Power Equipment

Code: CC-304

Date: June 19, 1995

SUBJECT: POWER TAKE OFF (PTO) CLUTCH SPACER ON 2130, 2135, 2160, 2165, 2185, 1440, 1641 MODEL TRACTORS. (1995 PRODUCTION)

Figure 1

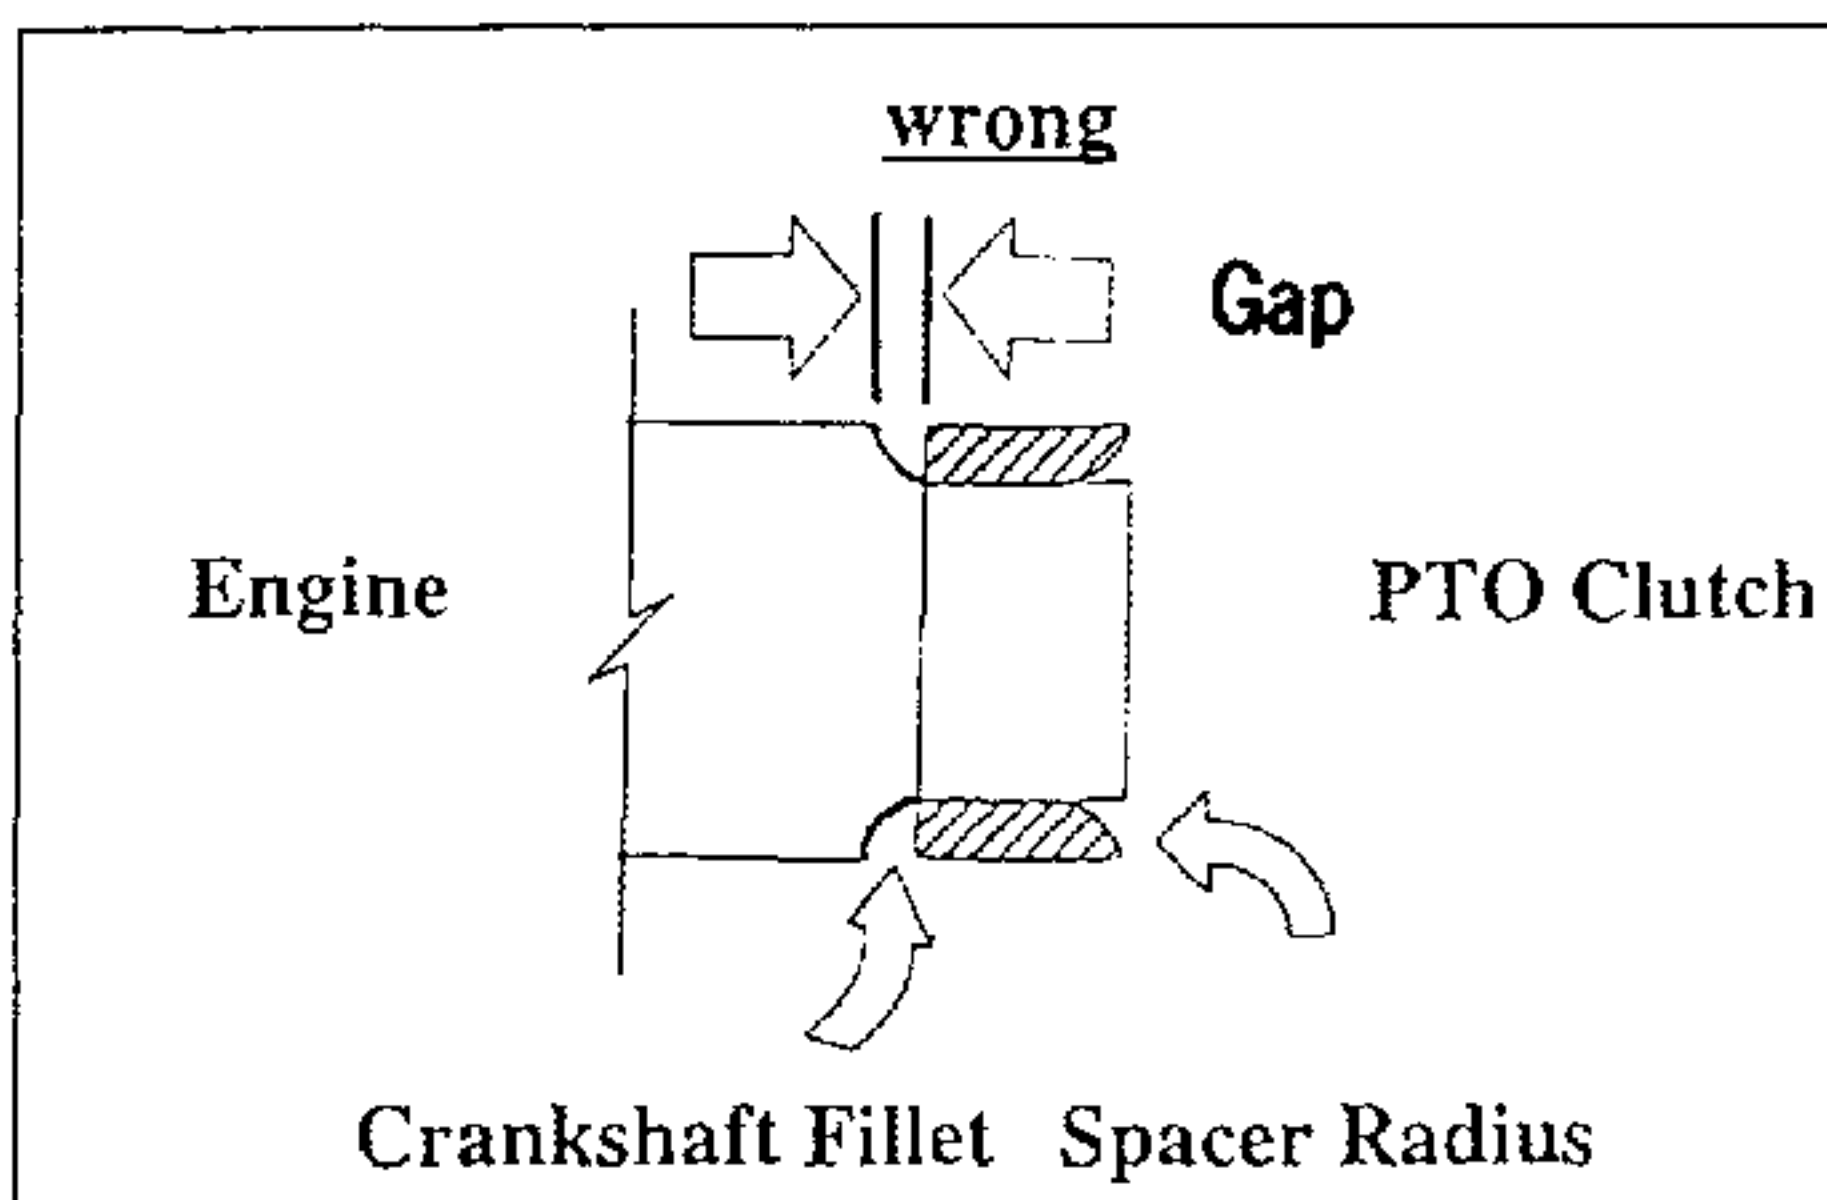
The following instructions are a visual way the service technician can quickly determine if the spacer has been installed properly. First the service technician must remove both side panels from the tractor in an area with plenty of light. Next look behind the PTO clutch, examine the area where the spacer comes in contact with the fillet of the crankshaft as shown in the illustrations below. If improperly installed, a gap will be apparent between the fillet of the crankshaft and the spacer as shown in figure one. If properly installed, the radius of the spacer will be in contact with the fillet of the crankshaft as shown in figure two.
